Kansas Department of Agriculture
 Division of Water Resources
CHANGE: PD WORKSHEET

KANSAS DEPARTMENT OF AGRICULTURE
Division of Water Resources
M E M O R A N D U M

RE: Water Right
File Nos. 148; 11,033 and 21,199

**APPROVAL OF APPLICATION
FOR
CHANGE IN
POINT OF DIVERSION
WATER RIGHT
FILE NO. 11,033**

Change in Point of Diversion, Application Map
30-18S-18W // Rush County

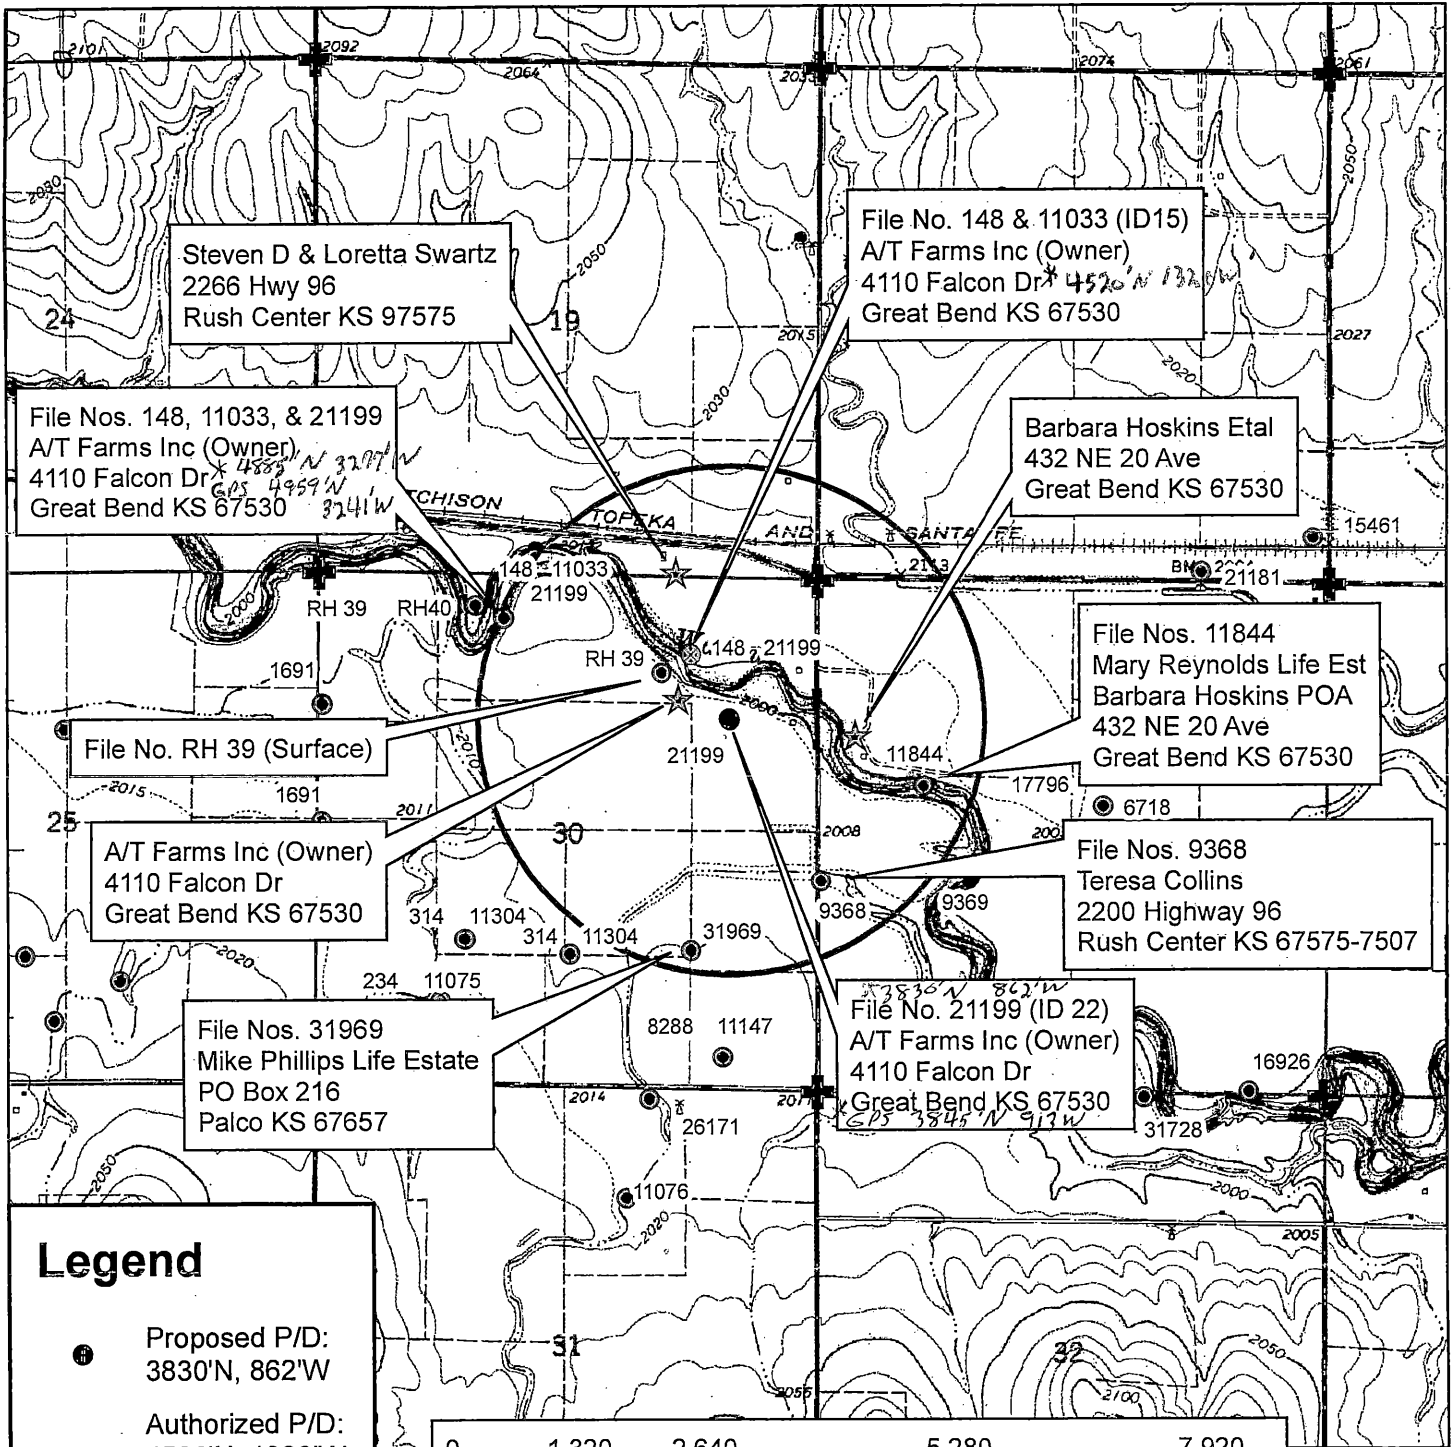
The proposed well is currently authorized by File No. 21199 (DWR ID #22) and produces from the same local source of supply which is considered to be main stem alluvium. The change will be moving quantity and rate away from the Walnut Creek. A well log for DWR ID#22 has been included.

The proposed change location will not meet spacing requirements to a domestic well owned by the landowner. In addition, the proposed location does not meet spacing to the well authorized by File No. 148 (DWR ID#15). However, the well is owned/operated by the landowner and is a part of the same place of use. A waiver of K.A.R. 5-4-4(c)(1)(C) is requested.

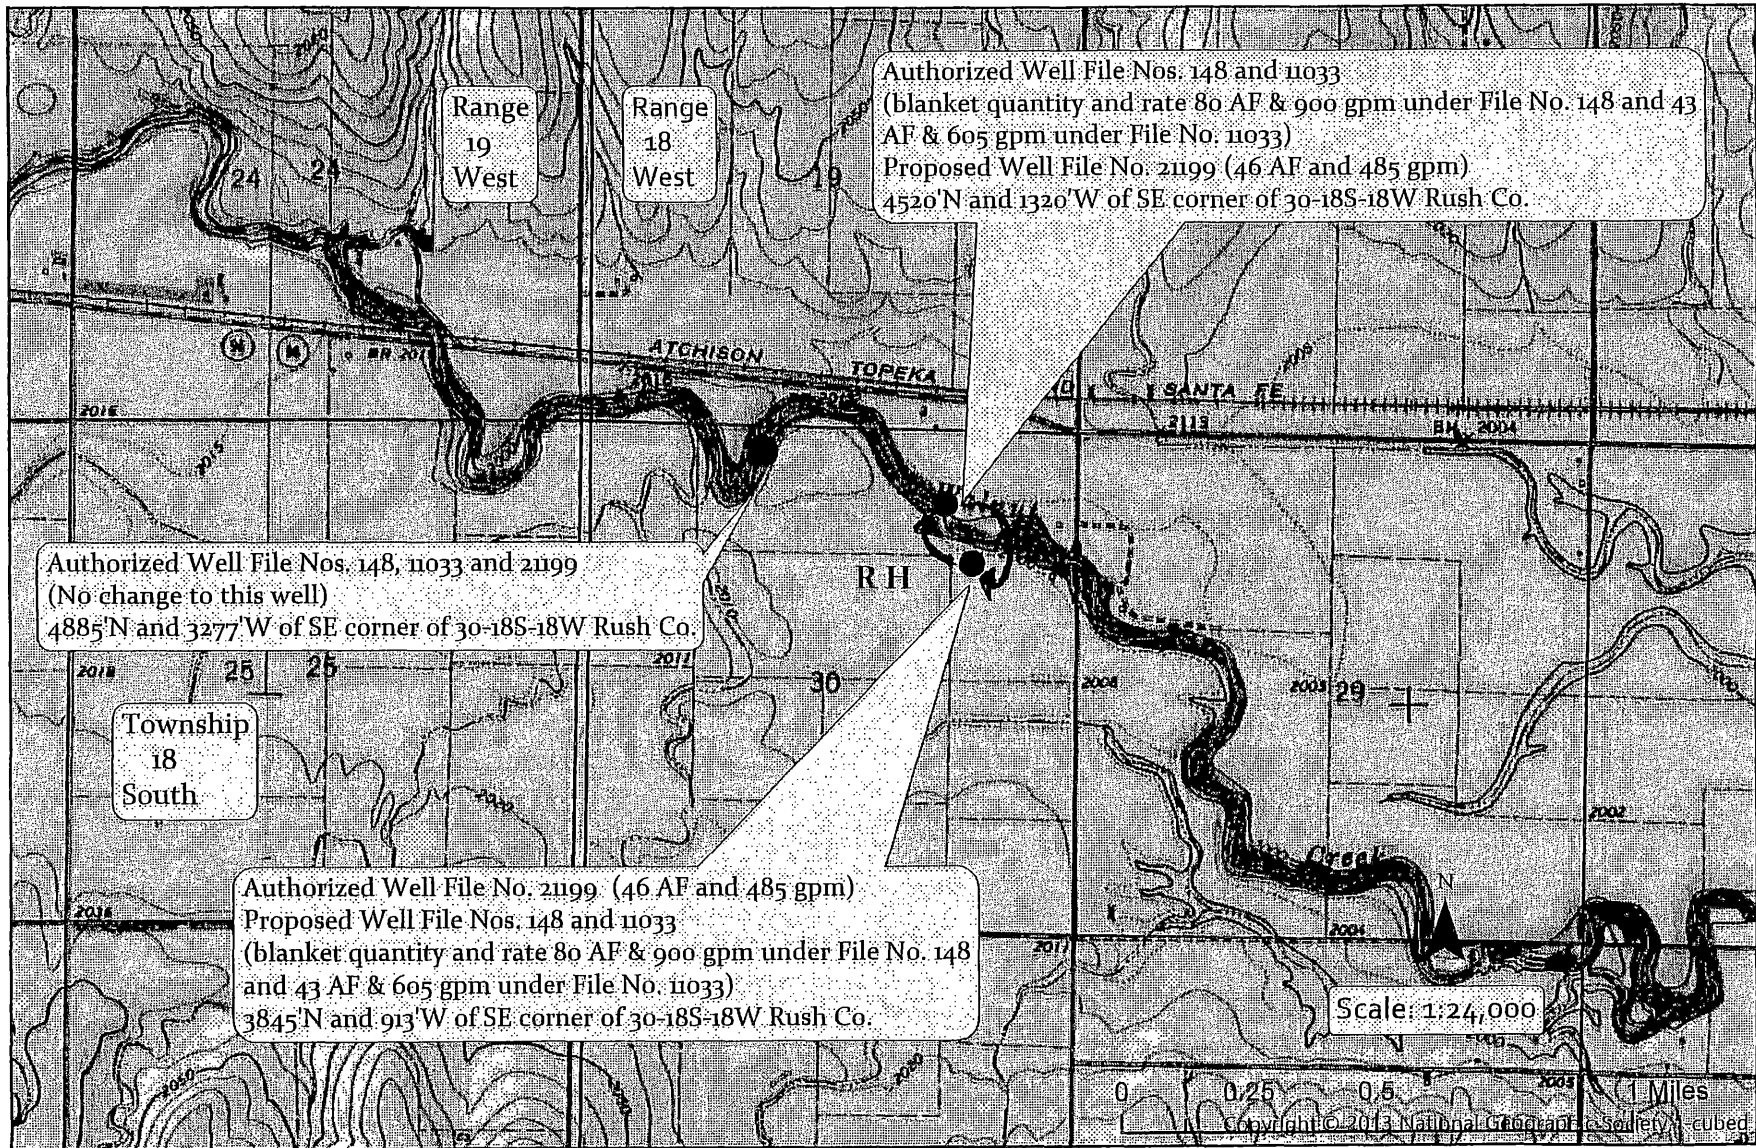
This change is proposing to flip flop p/d's between files to better accommodate how the farmer is using the wells. I've attached an explanatory map that helps show what is going on. Basically they are moving 21129 (46AF @485gpm) from a location south of Walnut creek 330' to an existing well location north of Walnut Creek about 130' from Walnut Creek. Also they are moving 11033 & 148 (80AF @ 900 & 43AF @ 605gpm = 123 AF total) from the location 130' North of Walnut Creek to the existing well 330' from Walnut Creek. The total change is about 800'...as such the wells don't meet spacing between one another.

We are proposing to waive 5-5-13 (distance to stream) for File No. 21199...it is moving closer but this should be a neutral or positive effect on the Walnut Creek based on the quantities and rates that are authorized to be pumped since 11033 & 148 is moving away from the creek (net change is moving 77 AF & 415 gpm further from the centerline of the Walnut Creek).

I'm good with this change and I think we can recommend approval. The memo only references a waiver of 5-5-13 (alluvium decrease distance to stream) which I agree with allowing as explained above. I also think we should waive spacing between the irrigation wells and spacing from both irrigation wells to the existing domestic well. It is kind of a formality since the owner of the domestic well is an owner of the irrigation rights, however, I still think we should issue both spacing waivers so they are on record. What do you think? If you like it, go ahead and pass on to Richelle and let me know if you have questions.
